THE CITY OF KEY WEST

Staff Report

Agenda Item: **Major Development Plan & Landscape Waiver - 3101 N. Roosevelt Blvd (00002360-000000)** - A request for a Major Development Plan and landscape waiver to redevelop an existing 81-unit hotel into an 80-unit transient condominium, while maintaining the on-site restaurant, retail seafood market, marina, and recreational rental vehicle uses, pursuant to Sections 108-91 and 108-517 of the Land Development Regulations of the City of Key West, Florida.

Proposed Site Plan

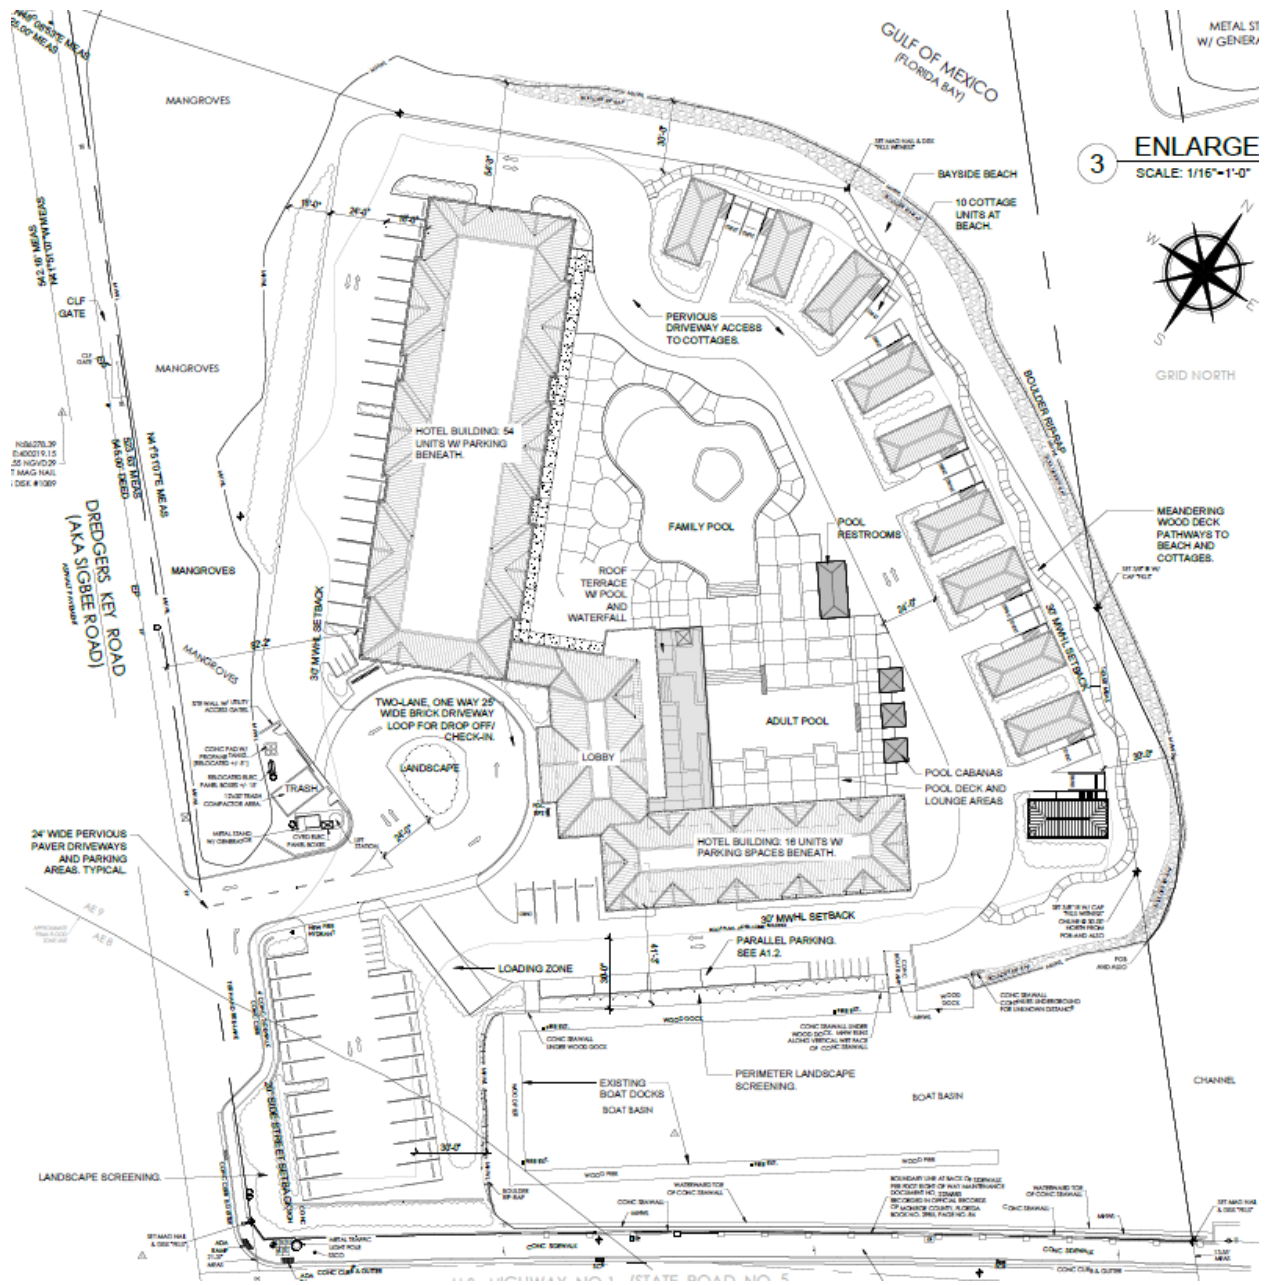
CODE SECTION	COMMENTS	COMPLIES?
Article III: Site Plan		
Sec. 108-279. - Location and screening of mechanical equipment, utility hardware and waste storage areas.	<ul style="list-style-type: none"> Per Utilities Department, the minimum dimension for the dumpster enclosure shall be 20' wide with a 12' wide opening installed with two six-foot wide gates; applicant shall confirm location and orientation with Waste Management. Applicant has included those dimensions in the site plan. 	Yes.
Sec. 108-286. - Pedestrian sidewalks.	<ul style="list-style-type: none"> New pedestrian walkways are proposed. 	Yes.
Article IV: Traffic Impacts		
Sec. 108-317. - Internal circulation system design and access/egress considerations. / Sec. 108-318. - Separation of vehicles, bicycles and pedestrians.	<ul style="list-style-type: none"> Applicant proposes a two-lane 25' brick driveway loop for drop-off/check-in which is accessible to the proposed parking lots. 	Yes.

Article V: Open Space, Screening & Buffers		
Sec. 108-346. - Open space, landscaping and removal of exotic vegetation.	<ul style="list-style-type: none"> Open space requirement is met. Exotic vegetation shall be removed. 	Yes.
Sec. 108-352. - Reducing landscape and/or bufferyard requirements.	<ul style="list-style-type: none"> A landscape waiver is being requested for the 30' required street frontage landscape buffer. The proposed street frontage landscaping is identified in the landscape plan. 	Waiver required.
Article VI: Landscaping		
Sec. 108-411. - Landscape plan approval.	<ul style="list-style-type: none"> Conceptual landscape plan approval has been issued by the Tree Commission. 	Yes.
Sec. 108-413. - Requirements along street frontage.	<ul style="list-style-type: none"> The site requires a landscape strip along the frontage at least 30' in width, with at least 120 plant units per 100 linear feet. The applicant requests a waiver to the frontage landscape minimum depth requirement. 	No. Waiver required.

Sec. 108-452. - Required sight distances for landscaping adjacent to public rights-of-way and points of access.	<ul style="list-style-type: none"> The applicant has provided the required clear zone adjacent to the intersection of two rights-of-way. 	Yes.
Sec. 108-517. - Waivers or modifications.	<ul style="list-style-type: none"> Per Section 108-517, the Planning Board may waive or modify the standards of Chapter 108 Article VI upon a finding that the modification meets the criteria outlined in Section 108-517. Staff has reviewed the application and found it consistent with these criteria. 	Yes.
Article VII: Off-Street Parking and Loading		
Sec. 108-573. - Special provisions within historic commercial pedestrian-oriented area.	<ul style="list-style-type: none"> Portions of an existing commercial structure are being remodeled and reconstructed. The total floor area and commercial uses remain the same. The existing total floor area is limited by maximum floor area ratio regulations; the floor area is currently legally noncompliant with regard to floor area and variances to maximum floor area ratio are not permitted. The property has an existing parking agreement with the City covering the uses that were in effect at the time of the resolution. However, the change to any commercial uses associated with the hotel's submerged land lease of adjacent parcel(s) could trigger parking requirements in the future.

CODE SECTION	COMMENTS	COMPLIES?
Article IV: Coastal Resources		
Sec. 110-88. - Wetland delineation; establishing wetland line. Sec. 110-89. - Development restrictions and interpretations. Sec. 110-91. - Wetland buffer zones.	<ul style="list-style-type: none"> The subject parcel includes mangrove/wetland area. A wetland delineation line is indicated on the plans. A wetland buffer of 25' is required for the site. Sec. 110-90 also allows an applicant to propose an alternative buffer methodology. The proposed site plan depicts permeable turf block pavers for the parking area along the west edge of the property. The pavers are located within a range of 2' and 15' from the wetland delineation line. Staff recommends that the applicant provide an alternative wetland buffer plan that addresses the criteria of Sec. 110-90(b)(1)-(3), in coordination with the South Florida Water Management District. That recommends that the plan be provided prior to final City Commission hearing. Per Sec. 110-89., the applicant must obtain all required permits or exemptions from state and/or federal agencies having jurisdiction 	Confirmation required prior to final approval.

1. The applicant shall provide a revised site data table that reflects the definitions for impervious surface and open space identified in the Land Development Regulations.
2. The applicant shall provide an alternative wetland buffer plan that addresses the criteria of Section 110-91.
